Title			Circuit 1 for Tx 07001		
Size A3	Number			Revision	
Date File	Oct. 15, 2006			Sheet 1 of 3

Title			Circuit 2 for Tx 07001		
Size		Number		Revision	
A3					
Date: Oct. 15, 2006			Sheet 2 of 3

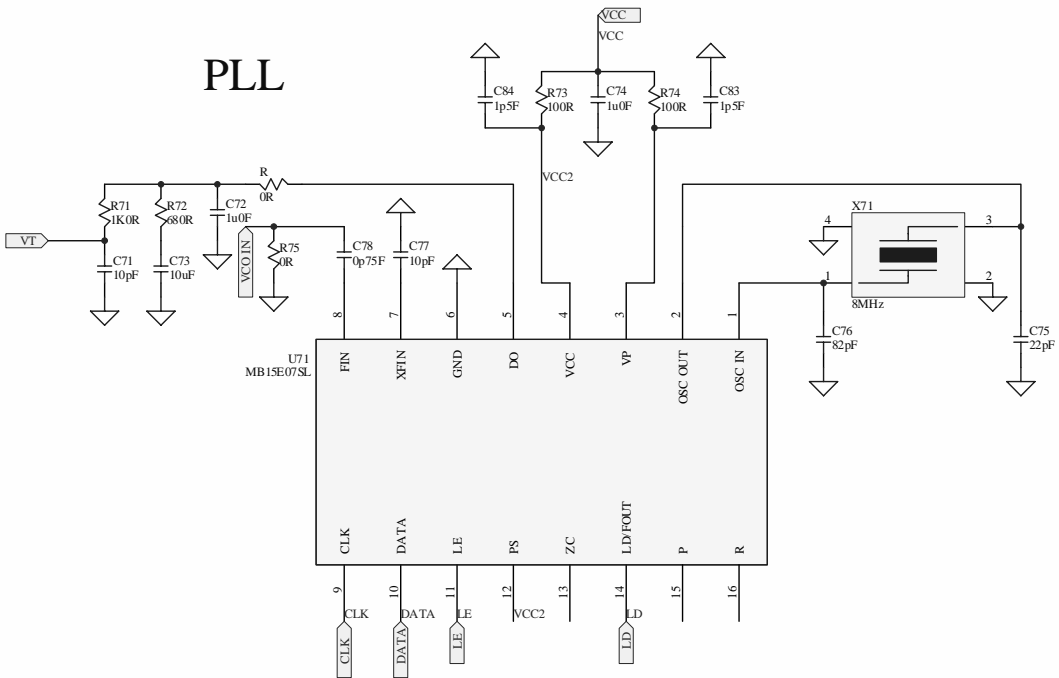
- * pin 26 of ASIC was connected to GND
- * ADC input circuits changed

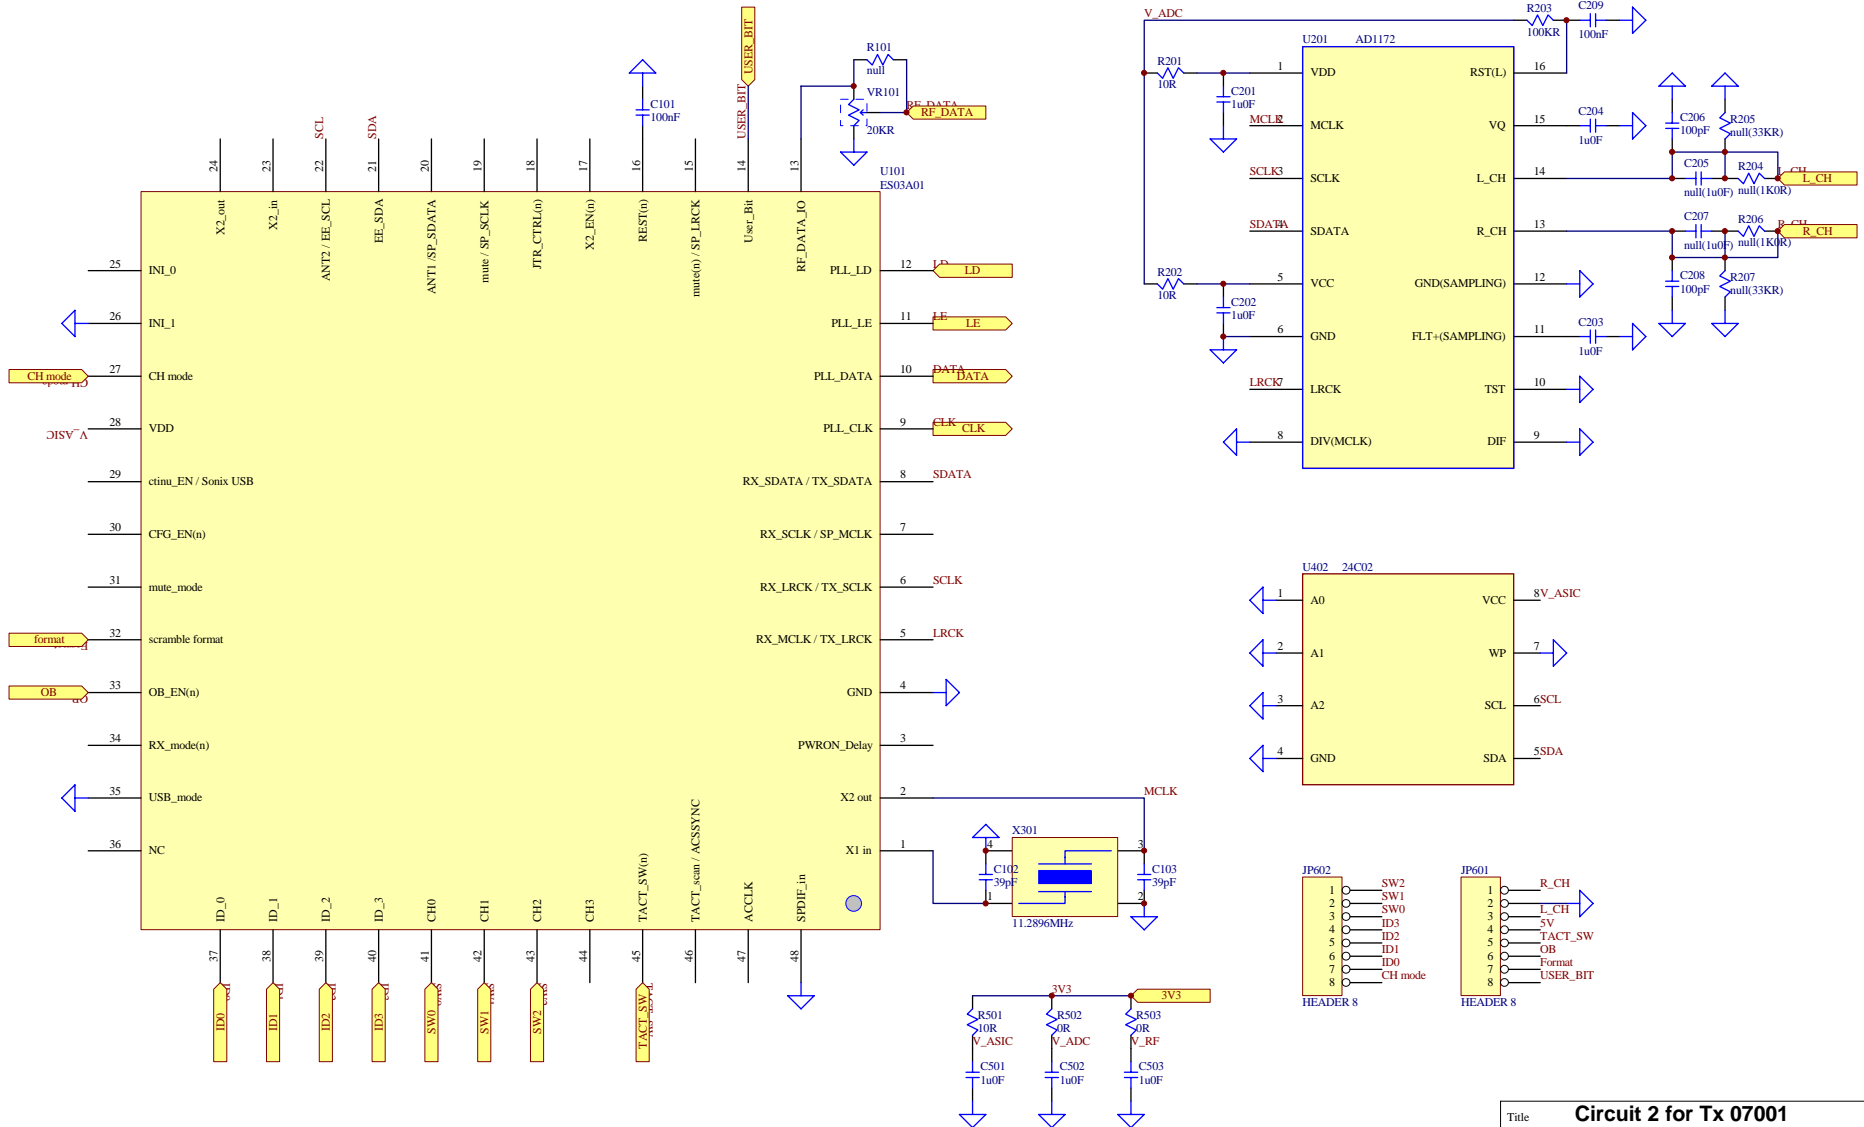
- * changing power supply: R501 220R to 10R / R502 120R to 0R / R503 39R to 0R
